N89 DERRYCLURE, TULLAMORE, Co.OFFALY- Road Safety Audit

**N80 DERRYCLURE
TULLAMORE, Co. OFFALY
ROAD SAFETY AUDIT STAGE 1**

Project Title	Derryclure Energy Centre
Report Title	Road Safety Audit Stage 1
Revision	
Status	FIRST ISSUE
Control Date	May 2010

Drawing showing Problem Locations

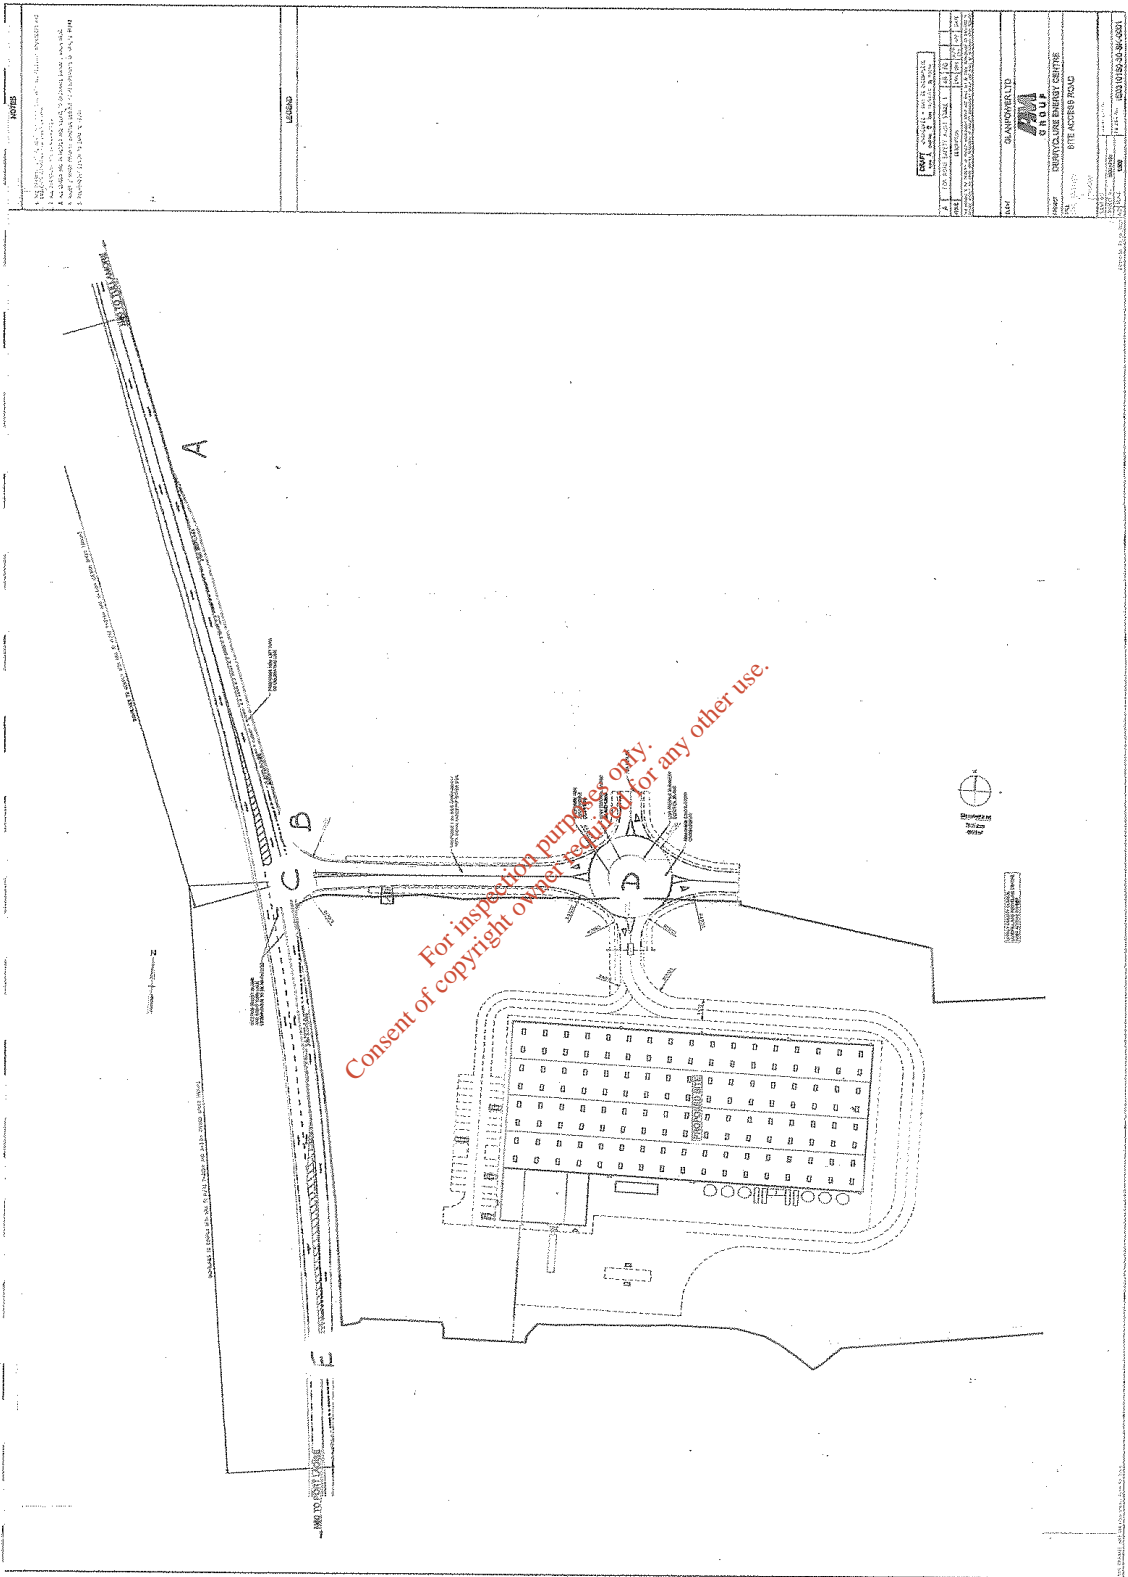
Location – Southbound approach to the access road junction - Locations A to B

There is no information provided relating to the drainage of surface water on the main carriageway. The revised layout will need to be adequately drained.

Location – Southbound approach to the access road junction - Locations A to B

A deceleration lane and a significantly greater left turn entry radius are proposed. The existing narrow hard shoulder runs close to a steep sided ditch and it appears that there may be inadequate clearance between the deceleration lane and the ditch hazard.

There should be an appraisal of the clearance. It may be necessary to pipe the ditch along this length.

Location – The access junction – Location C

Visibility of and from the junction is currently inhibited by chain link fencing and support posts. The drawing shows a 'Y' distance visibility splay to the left that excludes the southbound lane. Inadequate visibility can result in 'pull-out' type accidents.

It should be ensured that visibility from the junction is clear and unobstructed, in accordance with traffic speeds. The 'Y' distances from the access junction should be shown to the nearer edge of the major carriageway in both directions.

Location – The access junction - Location C

There is some concern that some large vehicles may have difficulty making some turning movements into and out from the access junction without the

risk of kerb collisions and over-run. For example, it appears that large vehicles may over-run the dedicated right turning lane when turning left from the access road. Restricted entry may extend the time required for turning movements with possible increased risk of collisions.

Location – The internal roundabout - Location D

The roundabout is to be provided with traffic separator islands on each of the four arms. This is supported as they provide clear guidance and control on vehicle entry and exit positions. There is some concern however that some large vehicles may have difficulty making some turning movements without the risk of kerb collisions and over-run.

Location – The new access junction and approaches - Locations A to E

There is no street lighting along this section of the N80. Large vehicles making right turns in or out from the access road will be exposed side-on to approaching main road traffic. During the hours of darkness on an unlit road, drivers approaching at up to 100 kph may not realise that a large vehicle is making such a turning movement. There may be a risk of side impacts.

There should be street lighting through the junction and immediate approaches.

Paragraph No. in Safety Audit Report	Problem accepted (yes/no)	Recommended measure accepted	Alternative measures (describe)	Alternative measure accepted by Auditors (yes/no)
3.1.1	YES	YES		
3.2.1	YES		PROPOSAL INCLUDES DIVERTING THE DITCH INTO ADJOINING LAND TO AVOID ROAD	YES
3.2.2	YES	YES		
3.2.3	YES		AUTO BACK SWERTH PATH	YES
3.2.4	YES		ANALYSIS TO BE USED TO CHECK GRASS IS SUFFICIENT	YES
3.3.1	YES		DRAWING'S NOTE LIGHTING DESIGN TO BE CARRIED OUT AT DETAILED DESIGN STAGE.	YES.
